# Memorandum 2

## **Fast Track Application FTAA-2507-1087: Ashbourne Development, Matamata**

### **Minute 3 of the Expert Panel dated 21 November 2025 - Response to Request for Information on behalf of Matamata-Piako District Council (geotechnical matters and groundwater)**

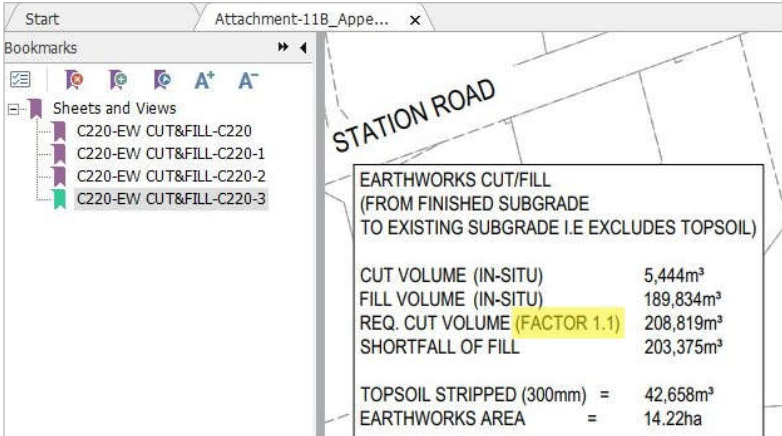
- Secondly, and more importantly, the earthworks plans refer to a compaction factor of 1.1 – for example:

EARTHWORKS CUT/FILL (FROM FINISHED SUBGRADE TO EXISTING SUBGRADE I.E EXCLUDES TOPSOIL)	
CUT VOLUME (IN-SITU)	5,444m³
FILL VOLUME (IN-SITU)	189,834m³
REQ. CUT VOLUME (FACTOR 1.1)	208,819m³
SHORTFALL OF FILL	203,375m³
TOPSOIL STRIPPED (300mm)	= 42,658m³
EARTHWORKS AREA	= 14.22ha

- A compaction factor allows for the loss of volume from natural soils to compacted filling. A factor of 1.1 equates to a -10% loss in volume and is reasonably common for 'conventional' soils. The Matamata soils are quite different as the weathered volcanic ashes are highly susceptible to particle crushing, and local Matamata experience is that the compaction factor is in the general order of  $\approx 1.3$  (I have checked this with a local engineer to make sure). So, unless I have mis-read the plans the Ashbourne earthworks are more likely to have -25% volume loss rather than the -10%. It is a puzzling inconsistency. I could not locate compaction factor information in any of the design documentation.

- The compaction factor discrepancy is directly relevant to groundwater related issues. If the finished ground levels have to remain as-is then additional fill will have to be found from somewhere. For just the northern part of the residential area (in the snip above) the deficit would equate to an additional 37,000 m<sup>3</sup>, or roughly 2,100 truck and trailer movements. The only other alternative would be to install considerably more subsoil drainage than what appears to have been brought into the design so far. This is a completely unproven concept.

# Total Rainfall - Tamihana - Matamata Aerodrome

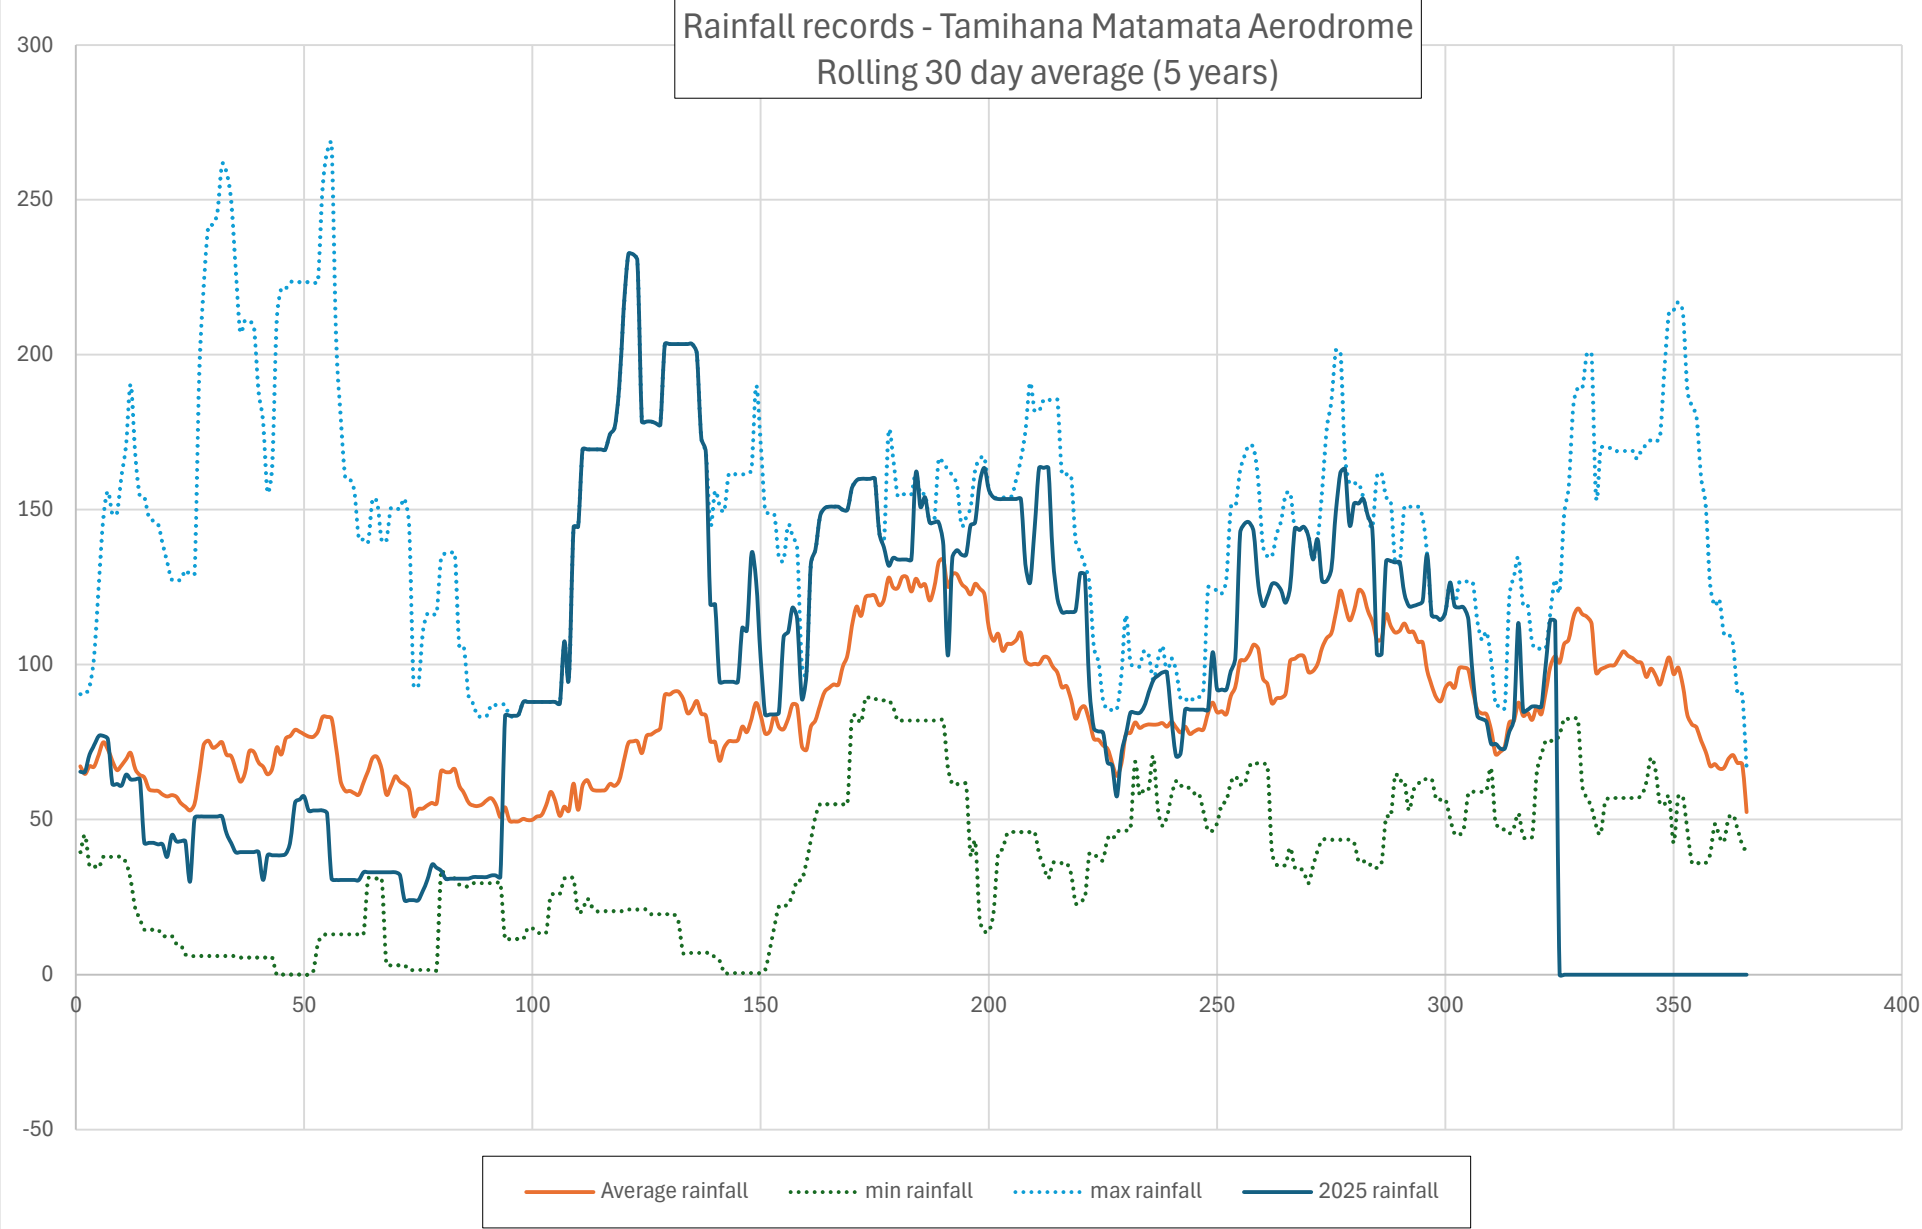
- It is not clear how the measured groundwater levels relate to historical averages. A simple way is to compare rainfall records for the 6 week period with historical rainfall records. I have undertaken a quick check as per the graphs appended to this Memo. The June-Oct 2025 rainfall in Matamata was above the historical average however nowhere near an upper bound such as the 95% percentile.

Figure 4

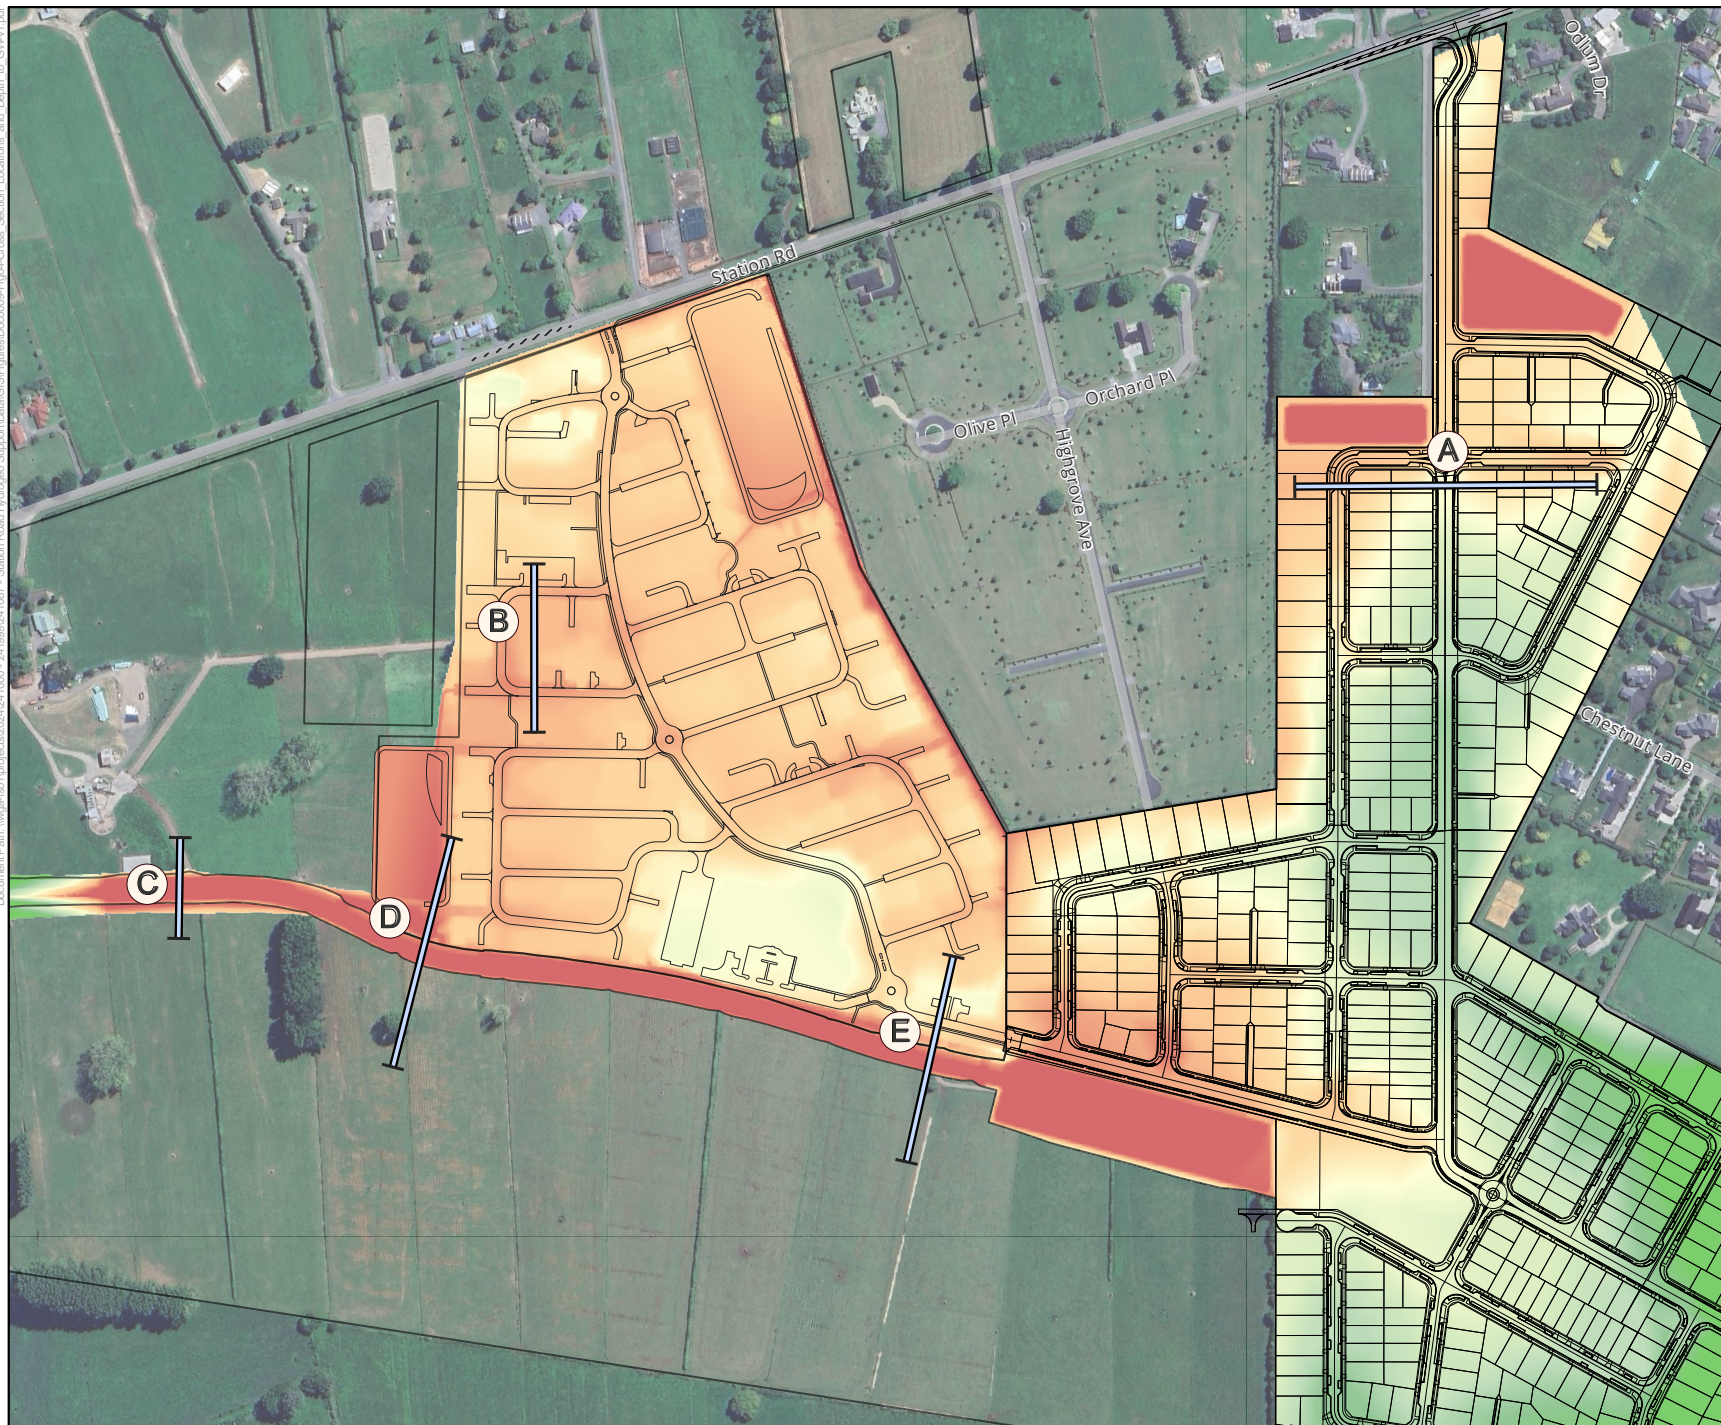
- Figure 4 of the WGA memo is important (see copy attached). It shows Depth to Groundwater in gradational/zone format. It looks to be at a quite detailed scale, however this is a reflection of the digital terrain model for the finished ground levels, not for the groundwater half of the equation. Informal feedback from WGA on 27/11/25 was that Figure 4 is based on the groundwater contours as per their Figure A1 (copy also attached).

- There are no details of the analytical model that generated the groundwater depth zonations shown in Figure 4. The colour gradations indicate simplifications and possible inconsistencies in the boundary conditions.

- WGA Figure 4 shows locations A to E which were analysed for groundwater drawdown via subsoil drainage. WGA staff have advised that Figure 4 does not include the drawdown effects of the subsoils. This makes sense because the shading pattern would otherwise be inconsistent.
- Maven have informally confirmed that the groundwater levels used in the civils design were as advised by WGA. There was no specific allowance for unknowns or unforeseens.
- It is not possible to reconcile WGA's Figure 4 with Maven's cut-fill plans and the stormwater design drawings. There appears to be locations within the residential area that do not comply with the clearance to groundwater table criteria.

- I attempted to verify WGA Figure 4 and the soakage disposal trenches in the Maven plans by determining the depth to groundwater at a small number of locations. This was not possible using the information provided.
